Sundry Print Report

Well Name: POKER LAKE UNIT Well Location: T24S / R31E / SEC 28 / County or Parish/State: EDDY /

Well Number: 413H Type of Well: OIL WELL Allottee or Tribe Name:

Type of Submission: Notice of Intent Type of Action: Plug and Abandonment

Poker Lake Unit 413H - Proposed WBD

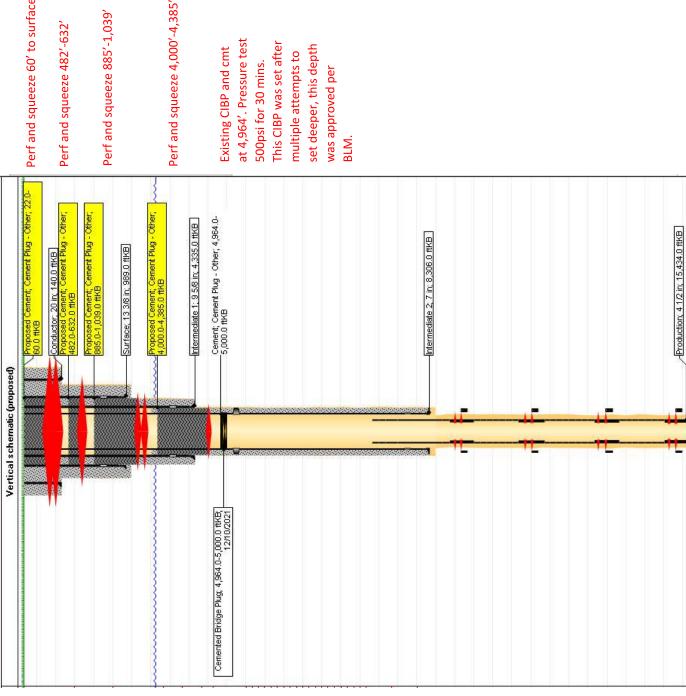
See revised procedure for requirements.

Sundry ID	2685566					
Plug Type	Тор	Bottom	Length	Tag	Sacks	Notes
						Perf and Squeeze at
						100' to surface.
				T 04 16	00.00	Verify at surface.
Surface Plug	0.00			Tag/Verify	30.00	(In/Out)
Top of Salt @ 985	925.15	1035.00	109.85	Tag/Verify		Deaf and a sure and at
						Perf and squeeze at 1039' to 885'. WOC
Shaa Diva	000.44	1020.00	100.00	Tog/\/orify	150.00	
Shoe Plug	929.11	1039.00		Tag/Verify Tag/Verify	150.00	and Tag. (In/Out)
Base of Salt @ 4113 Shoe Plug	4021.87 4241.65	4163.00 4385.00		Tag/Verify		
Snoe Plug	4241.00	4385.00	143.33	If solid		
				base no		
				need to		
				Tag		
				(CIBP		
				present		
				and/or		
				Mechanic		
				al Integrity		
				Test), If		
				Perf &		
				Sqz then		
				Tag, Leak		
				Test all		Perf and attempt
				CIBP if no		squeeze at 4410' to
				Open		4000'. WOC and
Delaware @ 4360	4266.40	4410.00	143.60	Perforatio	175.00	Tag.
				If solid		
				base no		
				need to

Tag		
				(CIBP		
				present		
				and/or		
				Mechanic		
				al Integrity		
				Test), If		
				Perf &		
				Sqz then		
				Tag, Leak		
				Test all CIBP if no		Tog CIDD at 4004
						Tag CIBP at 4964'.
TA CIPD @ 4064	1064.20	E014.00	440.04	Open Porforatio		Leak Test top of
TA CIBP @ 4964	4864.36	5014.00	149.64	Perforatio		CIBP.
